Access Compliance Report

Public Rights-of-Way

(Curb Ramps)

Intersection ID: 8116	Main Street: GOSSETT_AV	Cross Street: S_HOSKINS_RD	Location: E
ADA ID: 25DF5BD241F8	Ramp Type: PerpDiag	Initial Pass/Fail: Fail	Overall Compliance: No
Severity Score: 8.75			
Codes/Mitigation Info/Possible Solution		Field Measurements/Component Compliance

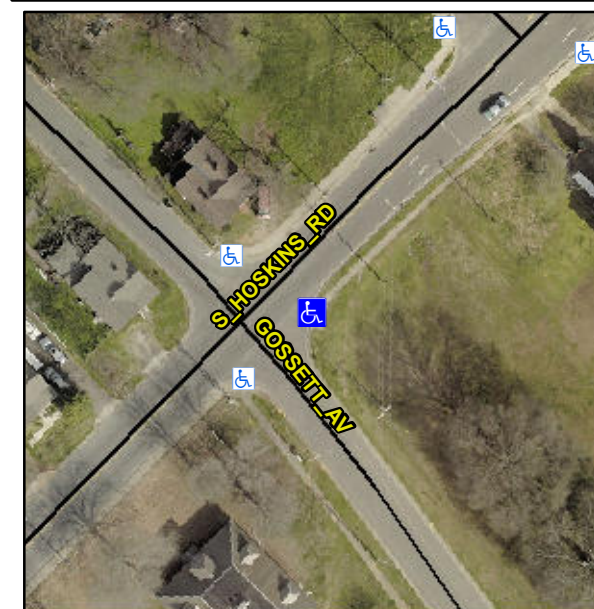
Not Found, R304.5.1

Compliance	Description	Data	Compliance	Description	Data
N/A	Ramp Length (in)	72.0	Yes	Ramp Slope (%)	6.1
No	Ramp Width (in)	47.5	Yes	Ramp XSlope (%)	0.3
N/A	Flare Type LT	N/A	N/A	Flare Type RT	N/A
N/A	Flare Slope LT (%)	N/A	N/A	Flare Slope RT (%)	N/A
N/A	Flare Traversable LT?	N/A	N/A	Flare Traversable RT?	N/A
N/A	Landing Length (in)	N/A	N/A	DWS Provided?	N/A
N/A	Landing Width (in)	N/A	N/A	DWS Contrast?	N/A
N/A	Landing Slope (%)	N/A	N/A	DWS Length (in)	N/A
N/A	Landing X Slope (%)	N/A	N/A	DWS Full Width?	N/A
N/A	Landing Curb? (Y/N)	N/A	N/A	DWS Offset (in)	N/A
N/A	Shared Landing?	N/A			
N/A	Gutter Ponding?	N/A	N/A	Gutter Slope (%)	N/A
N/A	Gutter Lip Ht (in)	N/A	N/A	Gutter X Slope (%)	N/A
N/A	Painted X Walk1?	No	N/A	Painted X Walk2?	No
	X Walk 1 Direction	To N		X Walk 2 Direction	To S
N/A	X Walk 1 Width (in)	N/A	N/A	X Walk 2 Width (in)	N/A
	X Walk 1 Slope (%)	2.8		X Walk 2 Slope (%)	0.4
	X Walk 1 X Slope (%)	0.1		X Walk 2 X Slope (%)	2.4

Remove & Replace Curb Ramp With Two New Directional Ramps or Equivalent.
